August 12, 1999

Subject: RCRA 3007 Information Request

KODAK ANSWERS TO EPA REQUEST FOR INFORMATION

TITLE B-119 HAZARDOUS WASTE TANK TRAILER #5746A
(first 28 characters will appear on aperture card)

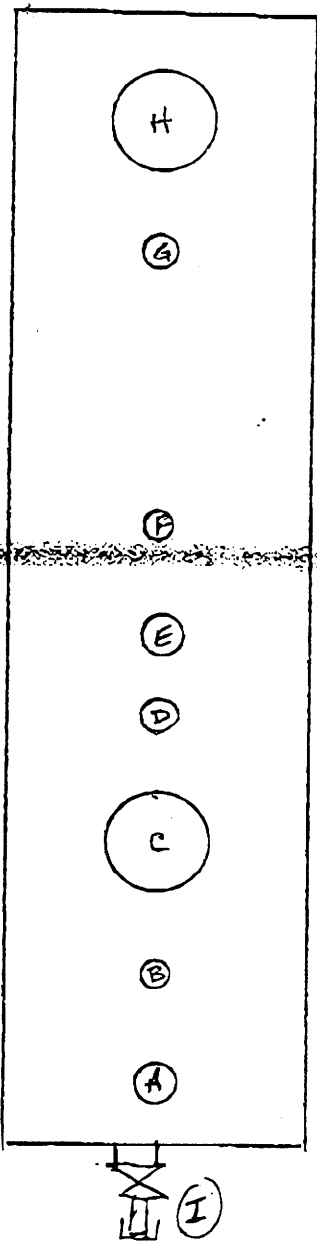
(a) Were these tank wagons monitored as required?

At the time of the inspection the two tank wagons located outside Building 119 were not monitored as required, but since that time the required monitoring has been completed.

Attached, please find the monitoring results. (Attachment I)

TAG #	DESCRIPTION	BASIC-GROUND PPM	READ PPM	ADJ. TOTAL PPM
263	A. 4" FILL	4	4	0
264	B. 1" FILL SHUT OFF	4	4	0
265	C. 22" MANWAY	4	20	16
266	D. 3" MESH TAPE	4	4	0
267	E. 4" RUMBLE DISC	4	4	0
268	F. 2" VENT	4	4	0
269	G. 3" BLANK FLANGE	4	4	0
270	H. 22" MANWAY	4	18	14
1196	I. 2" BOTTOM VALVE	2	2	0
